STAFF REPORT: 12/8/2021 MEETING

APPLICATION NUMBER: #21-7612

ADDRESS: 2522 W BOSTON BLVD

SCOPE: REPLACE ALL WINDOWS AND SHUTTERS, RESTORE ORIGINAL WINDOW OPENINGS (WORK COMPLETE WITHOUT APPROVAL)

Site Photo6, designation slide 1974: (South) front elevation showing front elevation shutters and wood paneling.

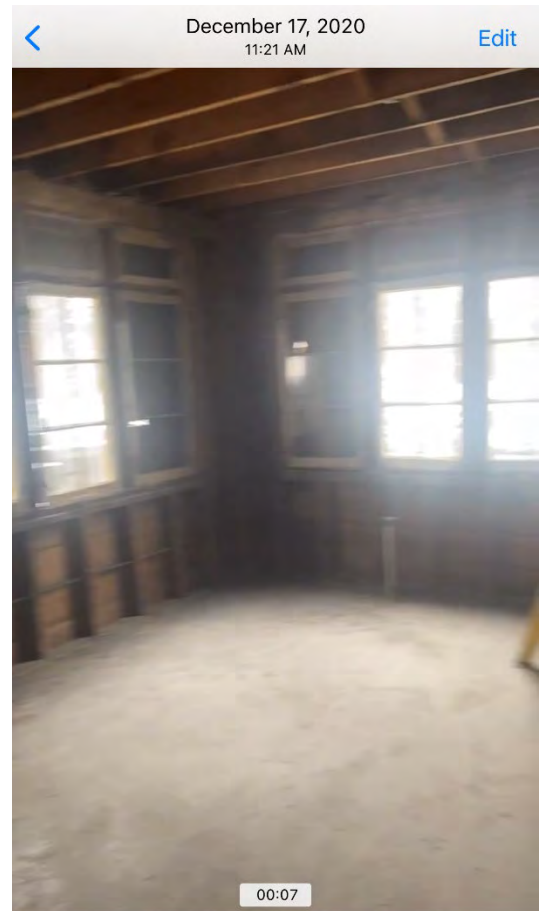
- Staff observed that the wood panels, which appeared as “shutters” in the mullied windows, on the front and side elevations were a careful intervention that occurred before the district was designated. These detailed wood panels were observed in place since the 1974 historic designation photo. The quality, craftsmanship and wear over time matches the proportions and details of the shutters. Staff received a photo from the Applicant that reveals windows and transoms under the interior drywall or plaster of the walls (see Photo 8). Despite the unknown status of this installation and the rationale for covering these transoms and windows, it is staff’s opinion that these panels were not distinctive character-defining features as they did not acquire their own historic significance under Standard 4. The restoration of the original windowed openings would instead be appropriate, especially since the original fabric was found present beneath this wood paneling and hidden in the wall.

- Staff confirmed that the applicant intends to replace the shutters, which have been removed. Staff observed that there is an original “butterfly shape” of the first-floor casement that remains, which had a version of shutter replacement that did not match the original size and did not have the top portion of the original shutters that would fit the arch of this window’s opening. Both designation photos of 1974 and 1980 show this feature of the shutters. (See photos 2 and 6.) It Staff opinion that these and the matching shutters of the front elevation contribute to the colonial architecture of this house and are therefore distinctive character-defining features of this historic building and that any replacement of new shutters should match in dimension, material and design of these original shutters.

- The dimensions of the replacement shutters have not been confirmed. However the material and design have been confirmed to replicate the original: wood and same design with the original shutters. There is a difference in dimension of design of the shutters that are shown by the designation slide, particularly with the first-floor casements windows on the left: the new shutters are smaller in dimension and lack the arch at the top. It is Staff's recommendation that these shutters be the same dimension, material and design as those shown in the designation photos.

- Replace six (6) front elevation shutters with six (6) wood shutters of same design and dimensions.

- The applicant replace the vinyl windows in these openings with wood or aluminum-clad-wood that matches in design, operation, dimension of the original windows and submitted to HDC Staff for review and approval.
- The applicant produce drawings or other documentation that show how the final dimensions, design, material and color are to match historic design of the original shutters as shown in the designation photo and submitted to HDC Staff for review and approval.

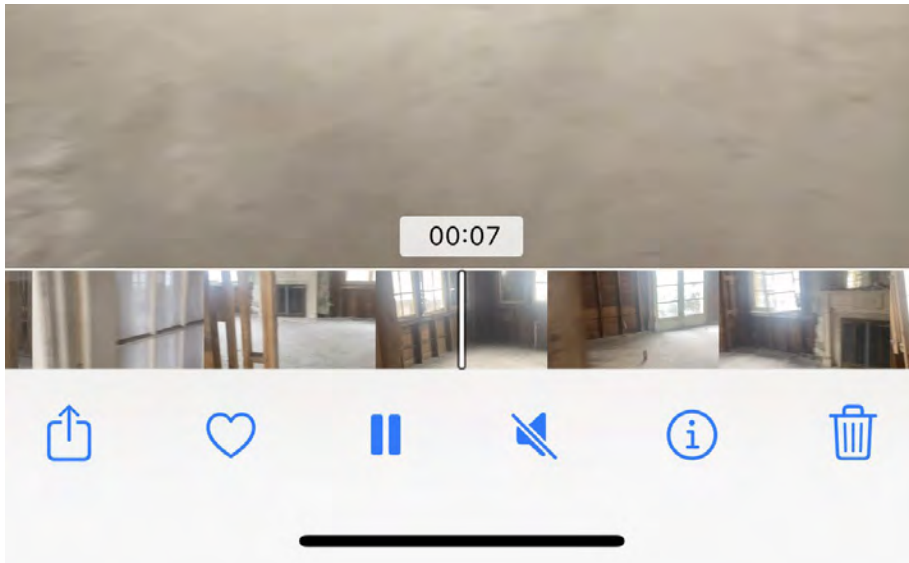
2., Also, the front of the house wood panels that you said had windows inside we still don't have a photo of that condition before it was changed. The window photo you provided (See attached) is not at this location because the dimensions of the window opening doesn't match. Can you send us the correct photo of the windows that were behind the wood paneling of the front of the house?
